***Technical Committee on  
Hanging and Bracing of Water-Based  
Fire Protection Systems***

**MEMORANDUM**

**SUBJECT:** **AUT-HBS AGENDA PACKAGE – A2012 ROP Meeting**

**REPORT ON PROPOSALS (ROP) MEETING**  
*NFPA Technical Committee on*  
*Hanging and Bracing of Water-Based*  
*Fire Protection Systems*

### Fig. 4A - Pipe Clamp for Sway Bracing

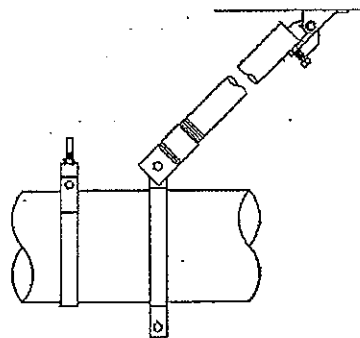
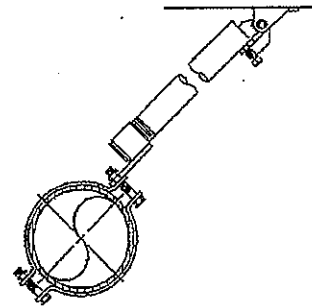
Longitudinal sway brace fittings and lateral sway brace fittings differ in both structure and function. The structural ability of the fastener flange of a listed longitudinal sway brace fitting is critical to its function. Their UL Sub 203A listing specifies assembly as a longitudinal sway brace fitting in conformance to NFPA 13. This requires alignment of the fitting to resist eccentric seismic force parallel to the fitting bolt flange. This flange is structurally stronger and more able to resist force applied parallel to the flat and against the edge. See drawing A.

IT IS PROBLEMATIC  
THAT LISTED LOAD RATING  
WOULD BE IDENTICAL FOR  
LATERAL AND LONGITUDINAL  
ORIENTATION.

Fig. 4

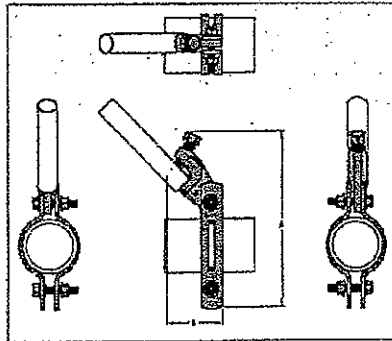
IT IS PROBLEMATIC  
THAT LISTED LOAD RATING  
WOULD BE IDENTICAL FOR  
LATERAL AND LONGITUDINAL  
ORIENTATION.

FIGURE 9.3.5.9.1 Maximum Loads for Various Types of Structures and Maximum Loads for Various Types of Fasteners to Structures.

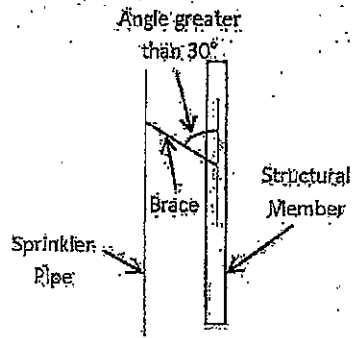
Recommendation: Replace "Length Under Head (in.)" with "Length In Timber (in.)" for lag screw/bolt length in Figure 9.3.5.9.1 table.

**Substantiation:** Length of lag screw/bolt under head is potentially misleading, as width of timber may not be enough to allow for screw/bolt to be completely contained within the timber. This clarifies the intent, which is to have the threads of a lag screw/bolt completely engaged in the timber. Further, it makes the text more consistent with similar language used for "through bolts" in the same figure.

Figure A.9.3.5.9.1.1 Brace Arrangement Not Allowed Where "L" Exceeds "W" Due to Creation of an Overturning Moment

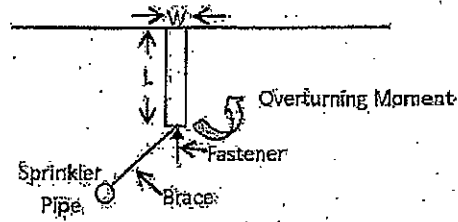
Recommendation: Add a new section 9.3.5.9.1.1 with an annex note and figure as follows:

The annex information is intended to show in pictures what is prohibited by the body of the standard since the text can be confusing.

A.9.3.5.9.1.1 See Figure A.9.3.5.9.1.1 for an example of an incorrect installation.

FIGURE A.9.3.5.3.5(a)/A9.3.5.4.3(a) Typical Location of Bracing at a horizontal change in direction.

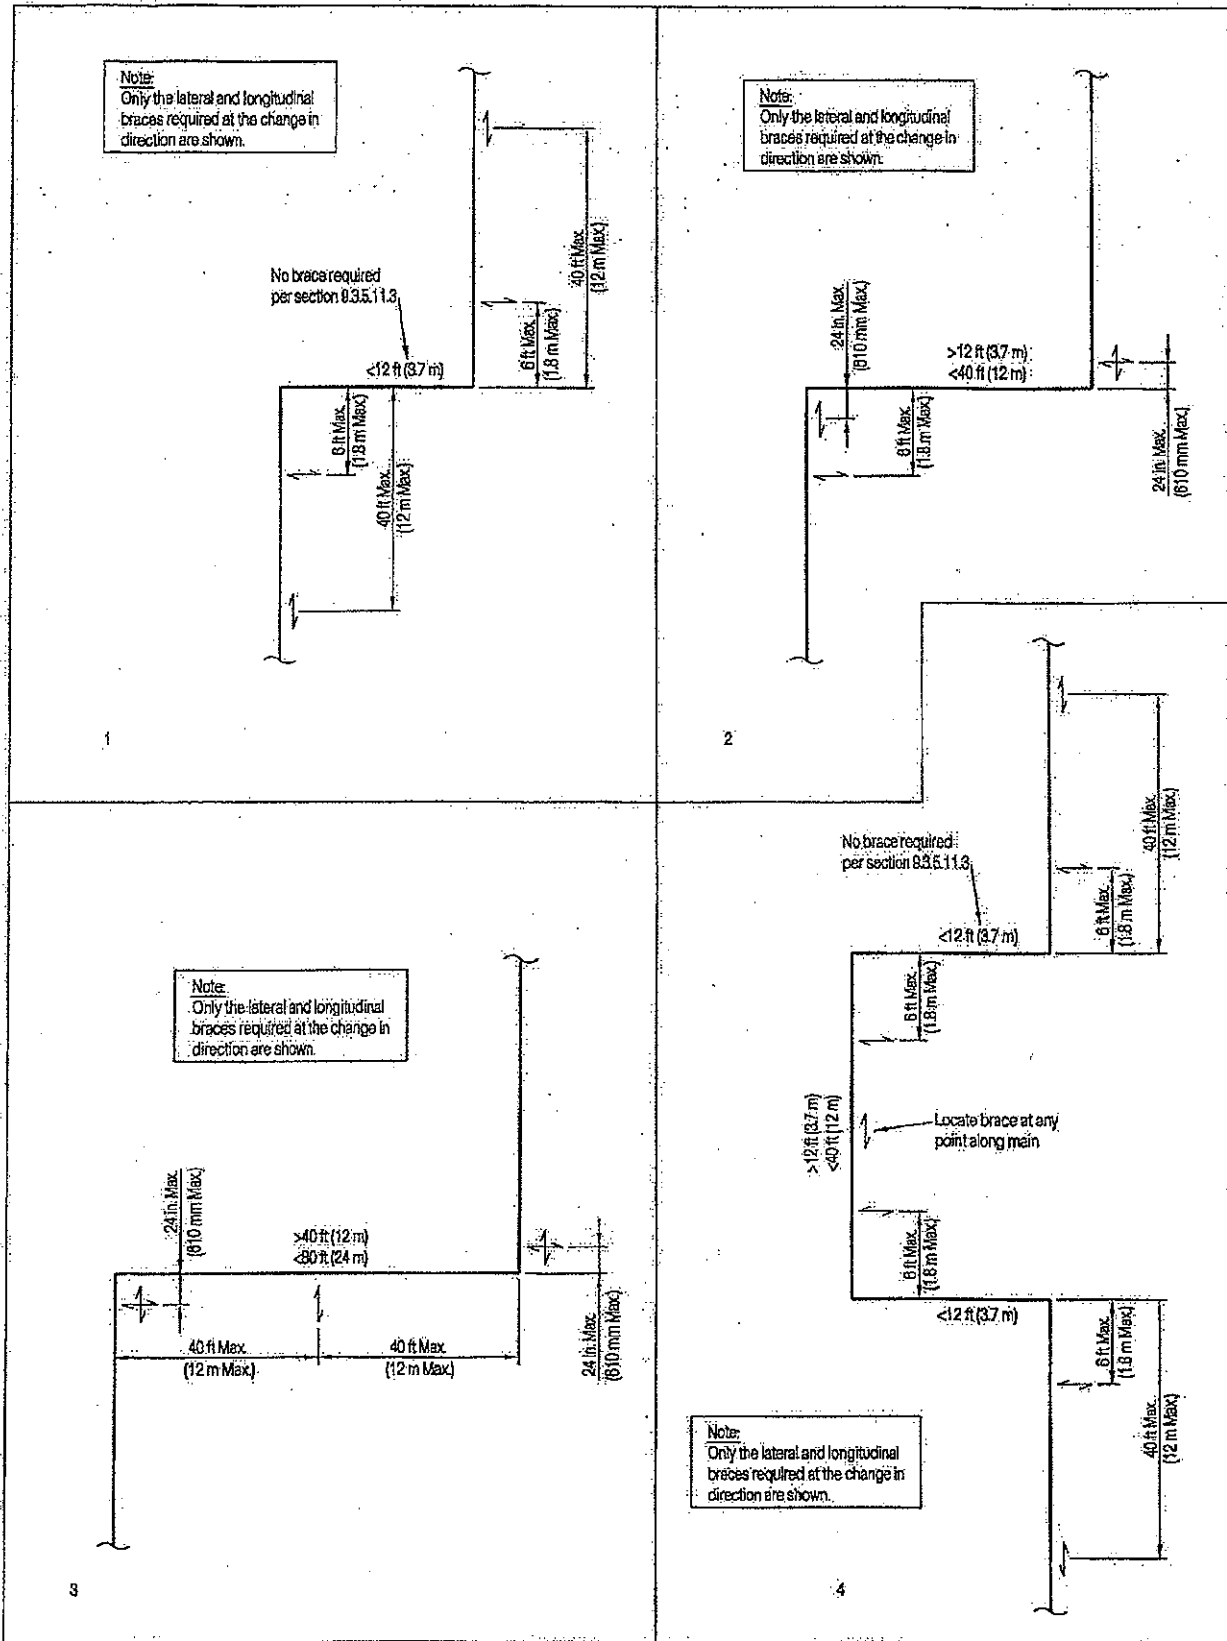
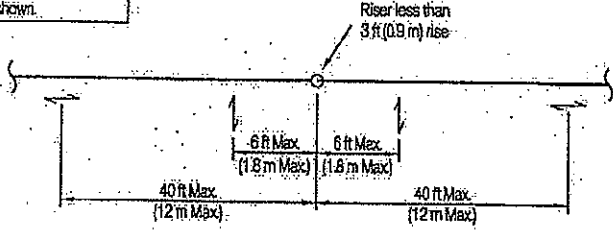
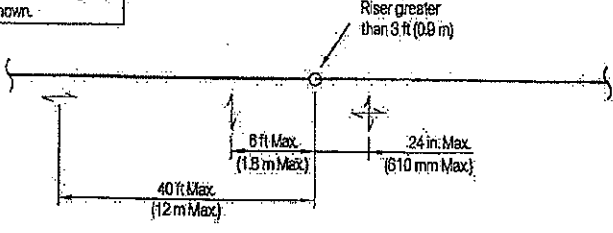
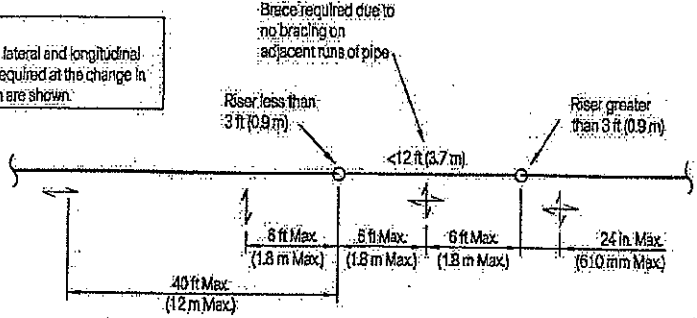
Recommendation: See proposed Figure A.9.3.5.3.5(a) Typical Location of Bracing at a horizontal change in direction.

Substantiation: The proposed figure indicates current bracing requirements and adds clarity to the intent of the standard by providing direction for locating bracing when a system main changes direction.

Recommendation: See proposed Figure A.9.3.5.4.3(a) Typical Location of Bracing at a horizontal change in direction.

Substantiation: The proposed figure indicates current bracing requirements and adds clarity to the intent of the standard by providing direction for locating bracing when a system main changes direction.

FIGURE A.9.3.5.3.5(b)/A.9.3.5.4.3(b) Typical Location of Bracing at a vertical change in direction.

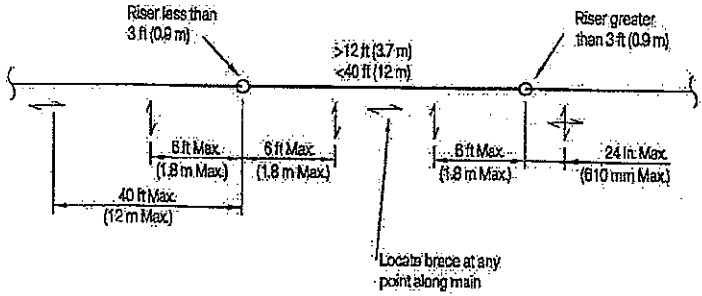
Recommendation: See proposed Figure A.9.3.5.3.5(b) Typical Location of Bracing at a vertical change in direction.

Substantiation: The proposed figure indicates current bracing requirements and adds clarity to the intent of the standard by providing direction for locating bracing when a system main changes direction.

Recommendation: See proposed Figure A.9.3.5.4.3(b) Typical Location of Bracing at a vertical change in direction.

Substantiation: The proposed figure indicates current bracing requirements and adds clarity to the intent of the standard by providing direction for locating bracing when a system main changes direction.

**FIGURE A.9.3.5.6(b) Typical Location of Bracing on a Tree System.**

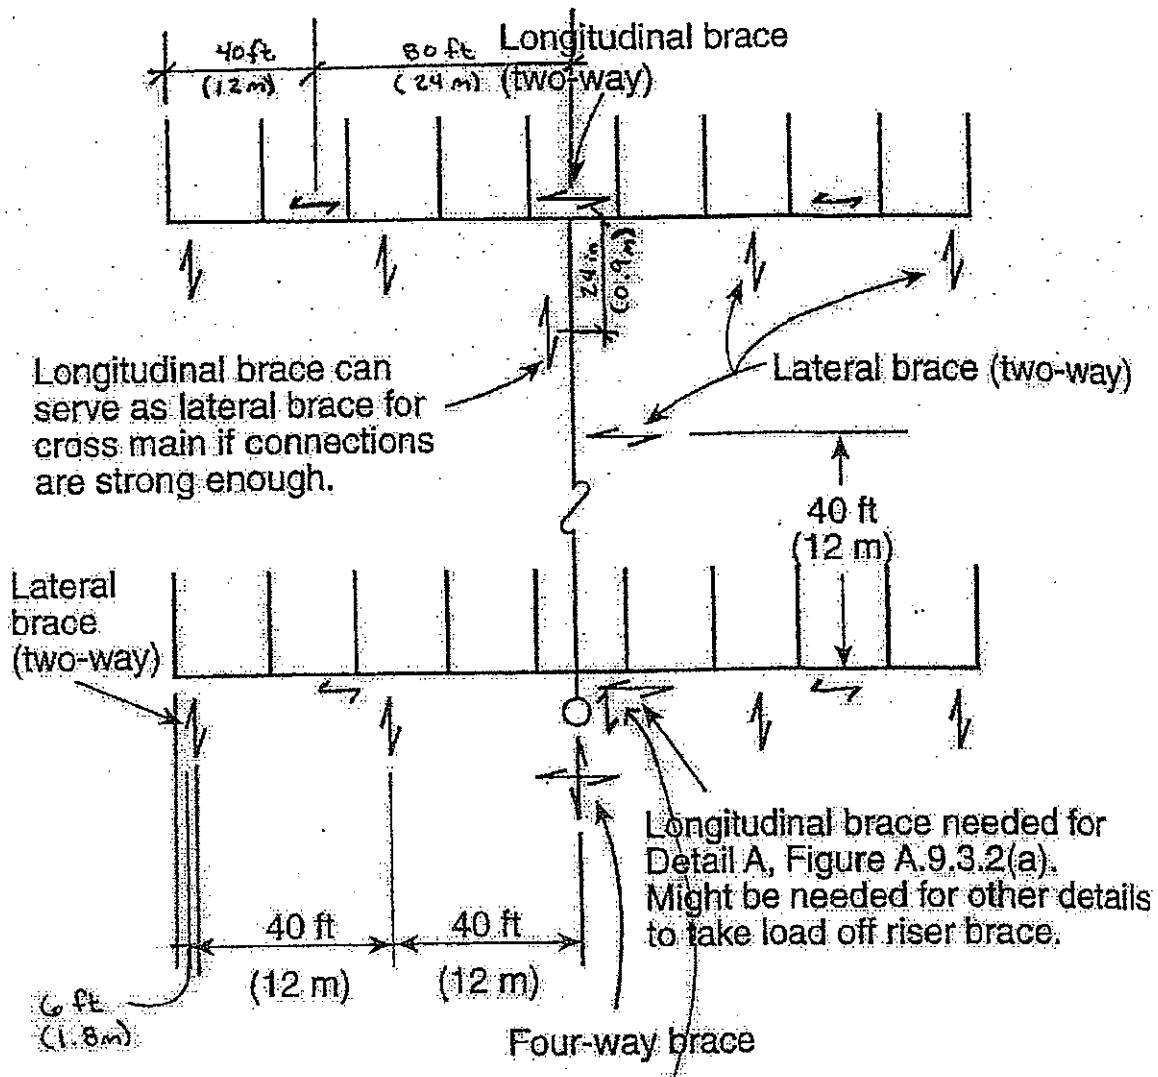
Recommendation: See revised Figure A.9.3.5.6(b) Typical Location of Bracing on a Tree System.

Substantiation: The proposed figures indicate current bracing requirements within the standard and add clarity to the intent of the standard by providing direction for locating bracing.

**FIGURE A.9.3.5.6(c) Typical Location of Bracing on a Grid System.**

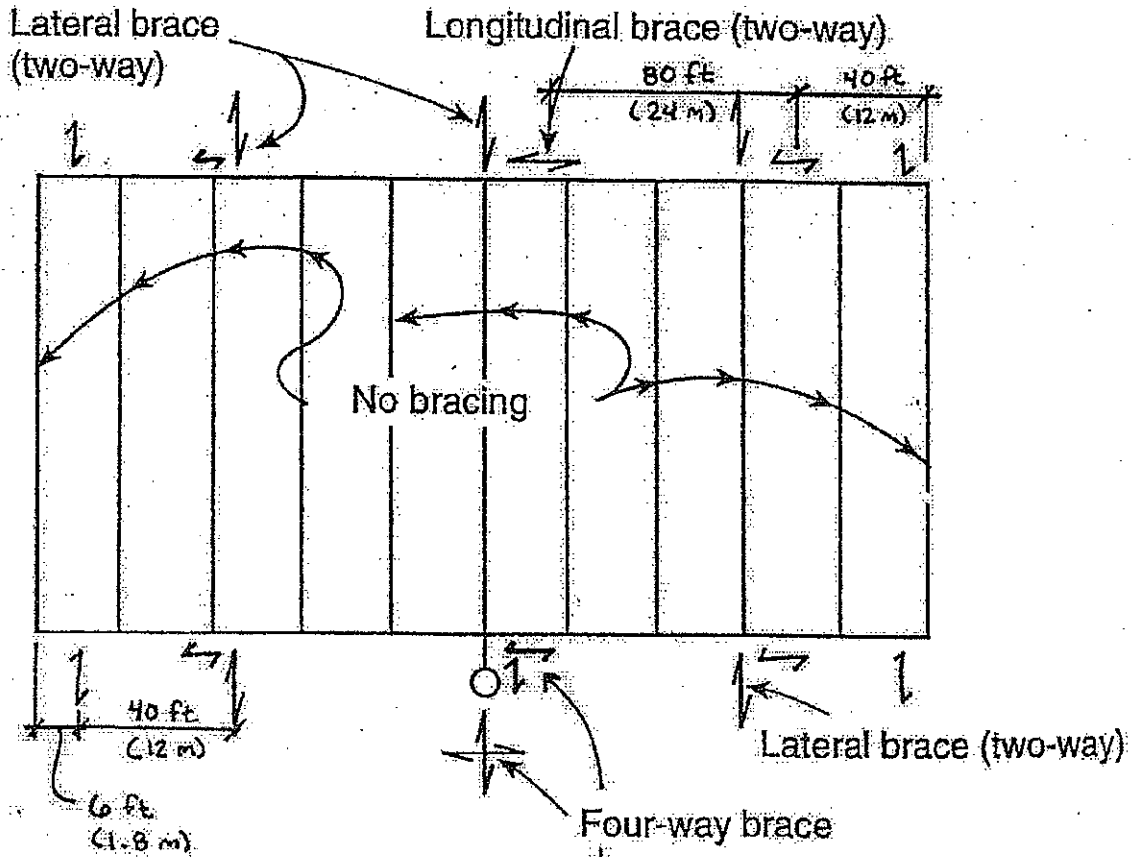
Recommendation: See revised Figure A.9.3.5.6(c) Typical Location of Bracing on a Gridded System.

Substantiation: The proposed figures indicate current bracing requirements within the standard and add clarity to the intent of the standard by providing direction for locating bracing.

**FIGURE A.9.3.5.6(d) Typical Location of Bracing on a Looped System.**

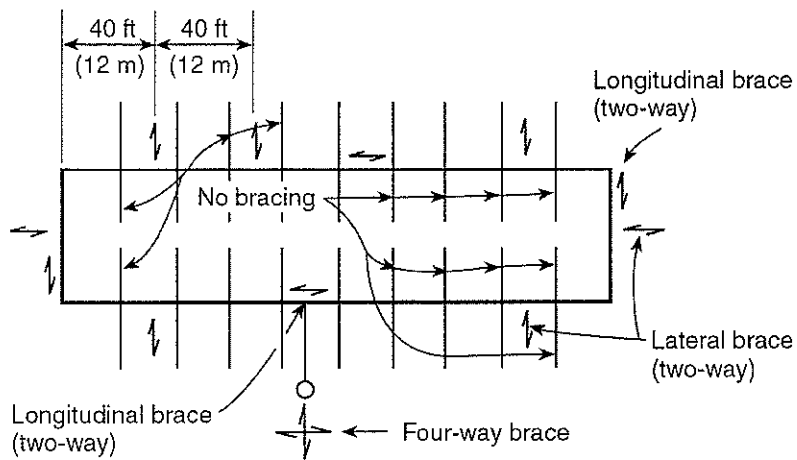
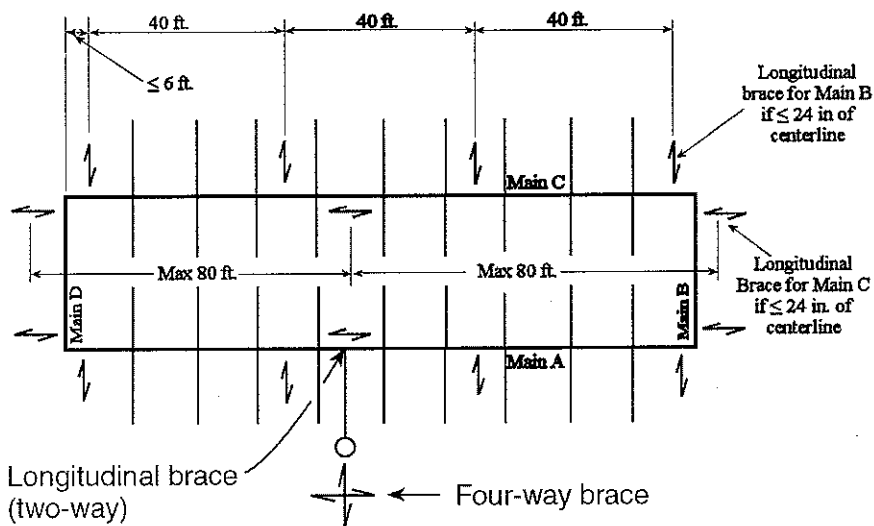
Recommendation: Delete existing figure and insert revised:

Substantiation: Existing figure suggests that last lateral brace on main may be spaced up to 40'-0" from the end of the main, which is contrary to 9.3.5.3.5, which limits this distance to maximum 6'-0". Further, the diagram did not address the possibility of a lateral brace functioning as a longitudinal brace for an adjacent main, provided the location was in accordance with 9.3.5.3.7. The revised figure provides clarification for both issues.

NFPA 13 (A12) ROP Log #417  
Figure A.9.3.5.11.3

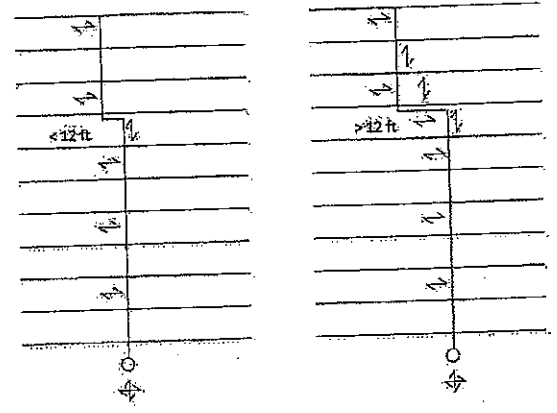
Recommendation: Revise text to read as follows:

Substantiation: A figure will clarify the application of braces when there is a change in direction of pipe less than and greater than 12 ft.

A.9.3.5.11.3 Examples of Brace Locations for Change in Direction of Pipe
